Product Change Notice (PCN)

件名: RH850/F1KM-S2, S4 および F1KH-D8 シリーズの生産拠点の追加および材料変更

発行日: 8/20/2025

ATJ 熊本品 LQFP マーク印字例 : R7F7017643AFD-C#BA1 (F1KM-S2 176pin)

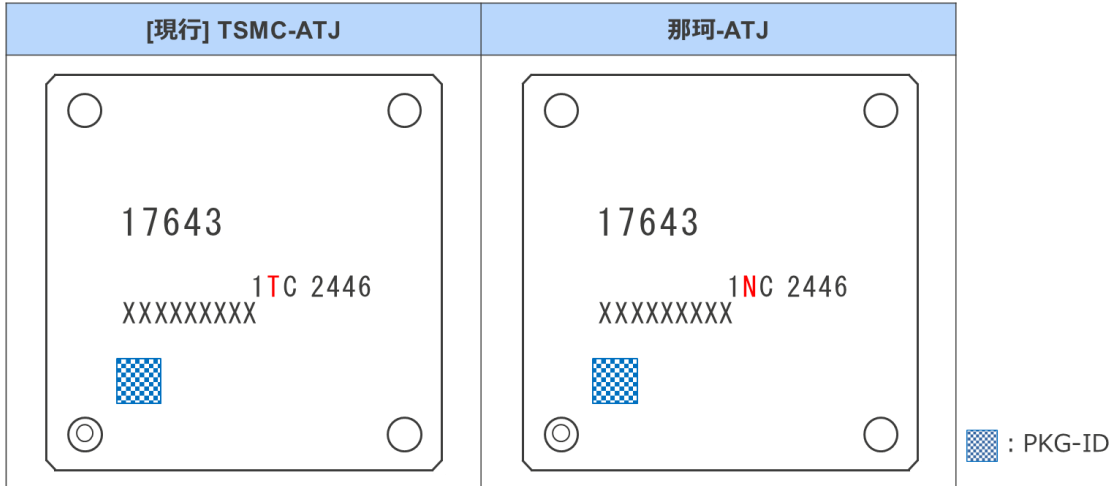
那珂品は赤文字部分が異なります。(TSMC 品:T, 那珂品:N)

蘇州品 LQFP マーク印字例 : R7F7017643AFP-C#BA1 (F1KM-S2 176pin)

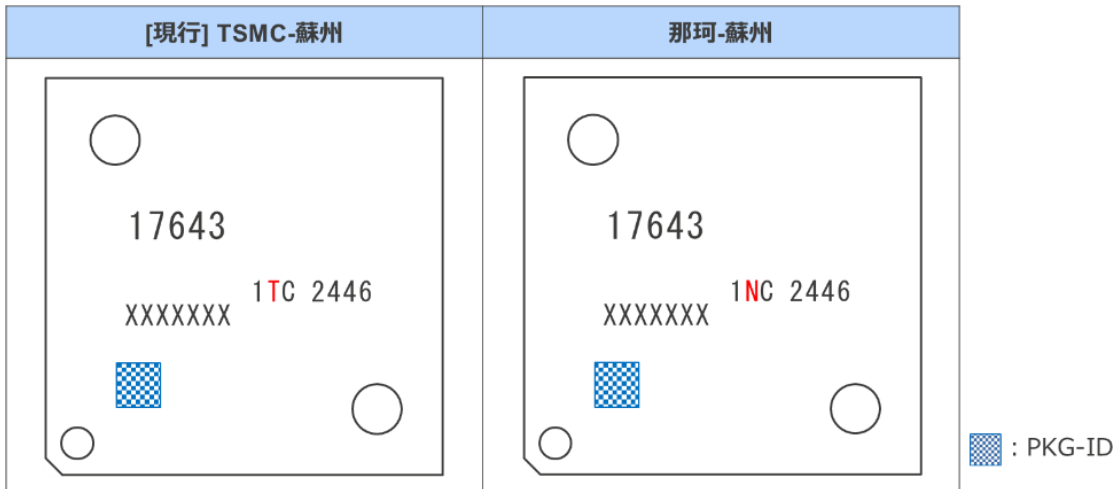
那珂品は赤文字部分が異なります。(TSMC 品:T, 那珂品:N)

米沢品 BGA マーク印字例 : R7F7016534ABG-C#BC1 (F1KM-S4 272pin)

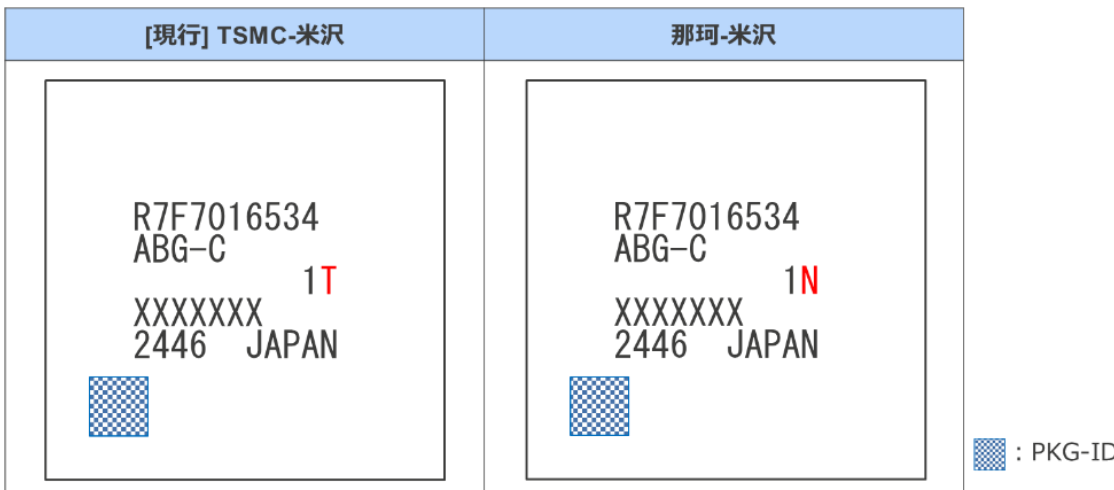
那珂品は赤文字部分が異なります。(TSMC 品:T, 那珂品:N)
